Clarification Note

Project Dragon

1. This Clarification Note has been prepared by Turley on behalf of LanzaTech UK Ltd (the Applicant). It provides clarifications in response to the key consultee responses received from Neath Port Talbot Council (NPTC) on a full planning application for the erection of a Sustainable Aviation Fuel (SAF) Production Facility at Crown Wharf, Port Talbot (ref. P2023/0858).

Re: Project Dragon, Port Talbot – Response to Red Twin and NRW Noise Comments

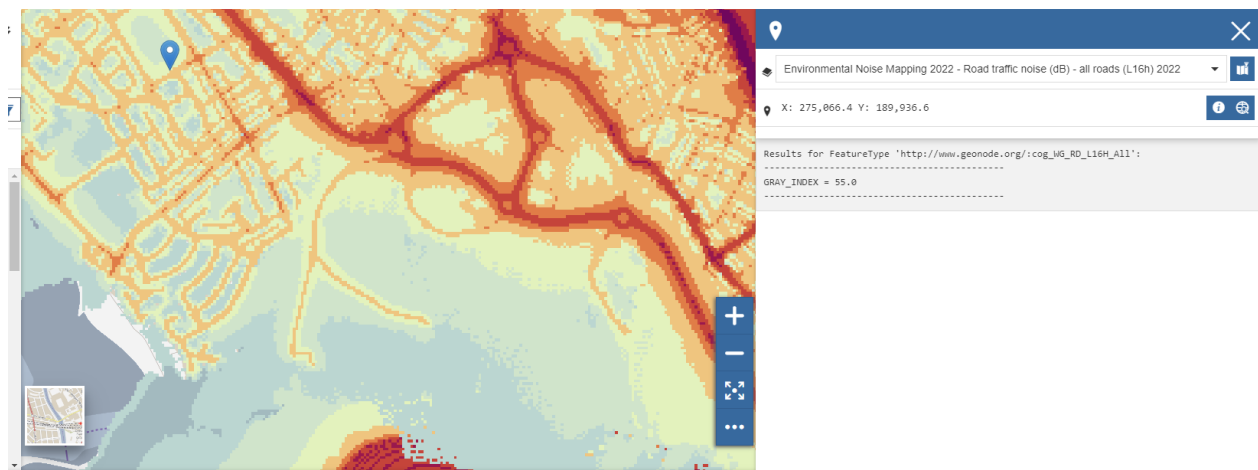
- 2) I note that no single event noise assessment has been undertaken for the staff vehicle car park to assess for car doors / boots slamming. It would be advantageous for such an assessment to be made in light of the proximity of this area to the NSRs

- 3) I would suggest a separate staff vehicle car park assessment that includes the above, assessed as a 'change in noise level' against IOA / IEMA guidance, would be beneficial.

The construction noise assessment which includes contractor parking noise has been carried out in line with BS 5228 which focuses on L_{Aeq} levels. This is the correct assessment methodology for assessing construction noise activities and in our opinion, a separate car park assessment for a temporary construction phase car park is not required.

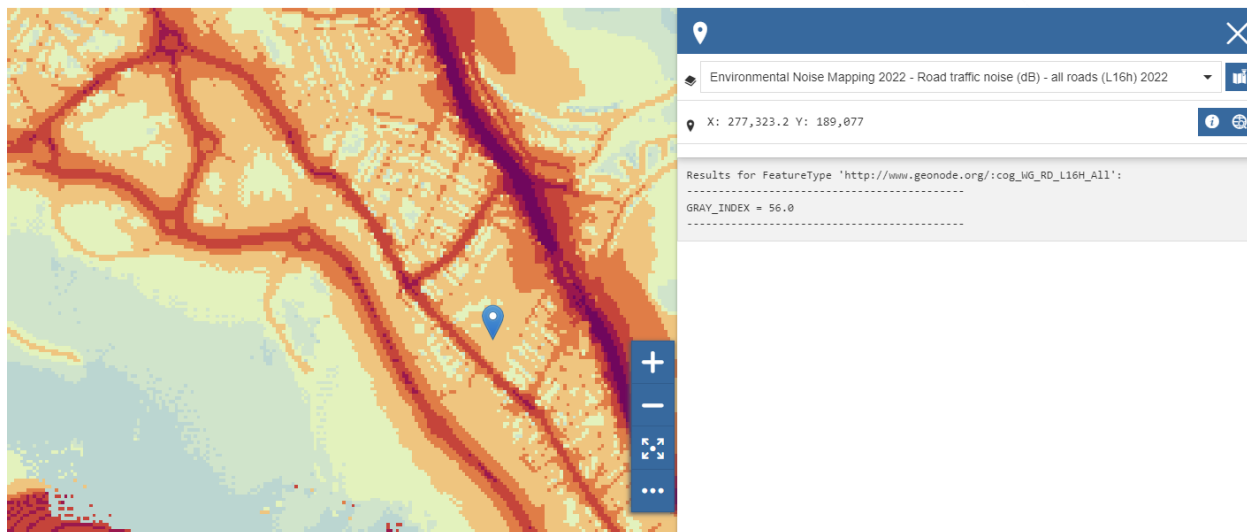
- 4) Ambient noise levels in both quiet areas seem quite high – higher than most of the other areas surveyed. I note the survey period was 2 x 15 minutes at both locations. Were there any noisy activities taking place nearby these two areas during the survey period that aren't typical occurrences? Would longer survey period yield different results and therefore affect the outcome described in para 7.2.12 of the operational noise assessment and table 6.1 of the construction noise assessment?

Ambient L_{Aeq} levels at Position 8 (Vivian Park) were measured at 55-56dB. There were no noisy activities in the area at the time of measurement and road traffic noise controlled the levels. Using the Welsh Government Noise Map to check levels indicates daytime 55dB $L_{Aeq,16hr}$ from road traffic noise – see below:

Ambient L_{Aeq} levels at Position 9 (Talbot Memorial Park) were 56-59dB. There were no noisy activities in the area at the time of measurement and road traffic noise controlled the levels. Using the Welsh Government Noise Map to check levels indicates daytime 56dB $L_{Aeq,16hr}$ from road traffic noise – see below:

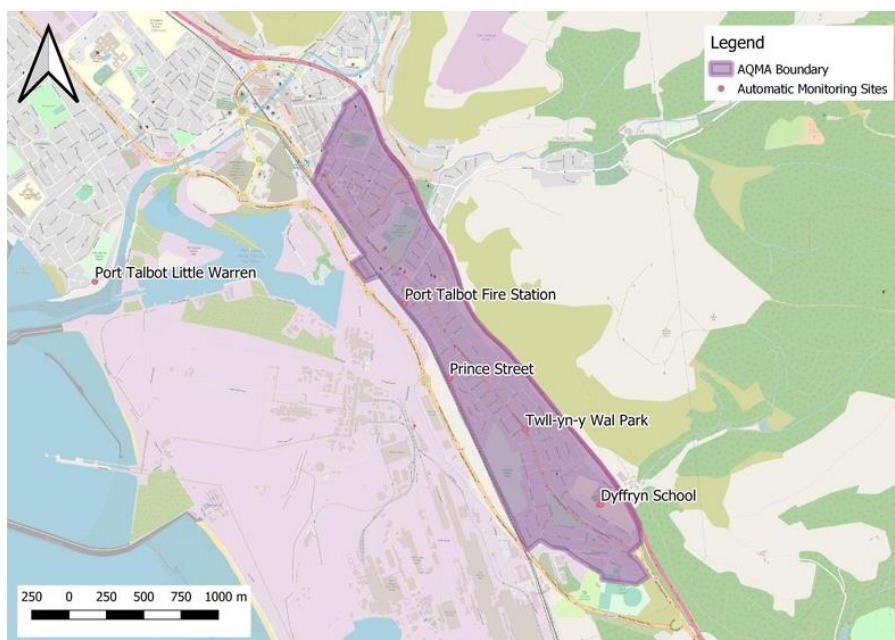
5. Recommendation AQ4 – Applicant to take into consideration stringent PM_{2.5} target of 10 ug/m³

The PC from the onsite long-term emissions are predicted to be less than 0.1 µg/m³. When assessed against a PM_{2.5} target of 10 ug/m³ the PC is less than 1% of the target value and predicted concentrations at all receptor locations where the long-term limit values apply would remain at background concentrations as indicated in Table 11.7.3, Appendix 11.7. Impacts on PM_{2.5} would therefore be negligible when assessed against the current UK limit values for PM_{2.5} and the EIP target values.

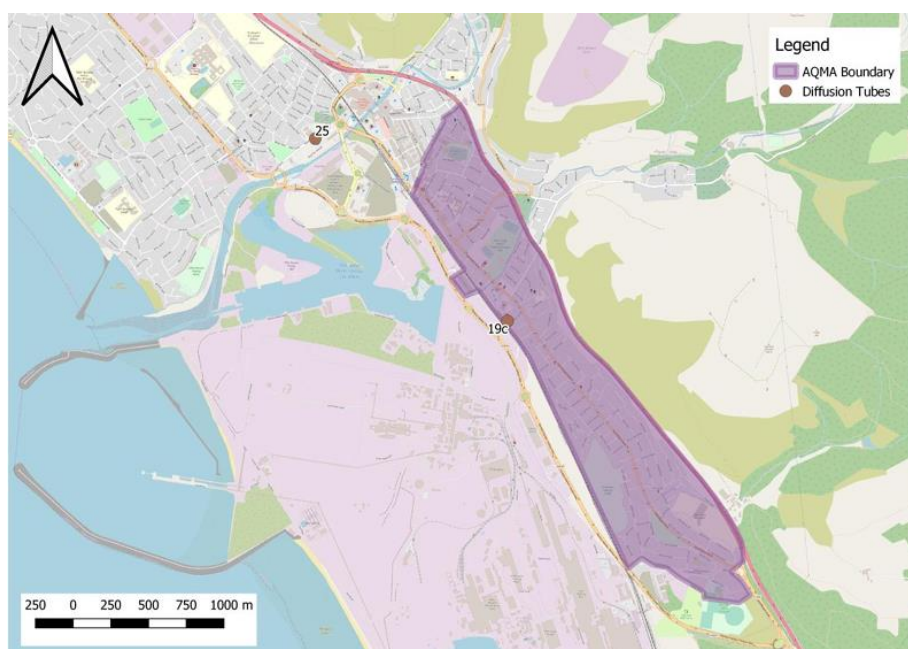
6. The applicant should undertake a model verification exercise which would be representative for the study area

The Council operated automatic sites located in Port Talbot are all classed as industrial sites, with only one being located at a roadside location – Site TW1 0 Twll-yn-y Wal Park (but also classed by the Council as an industrial site) – Please see map below. This site only monitors PM₁₀ so can not be used to undertake model verification for NO₂.

NO₂ is monitored at two other locations in Port Talbot using diffusion tubes. However, as is shown in the map below, neither is at a roadside location.

The above review shows that there is no suitable monitoring data in Port Talbot that can be used to undertake model verification, the use of an arbitrary adjustment factor was therefore used. However, this factor was not derived from a single modelling assessment it was obtained by taking the average of a number of adjustment factors obtained from a number of different road modelling assessments undertaken in similar urban environments.
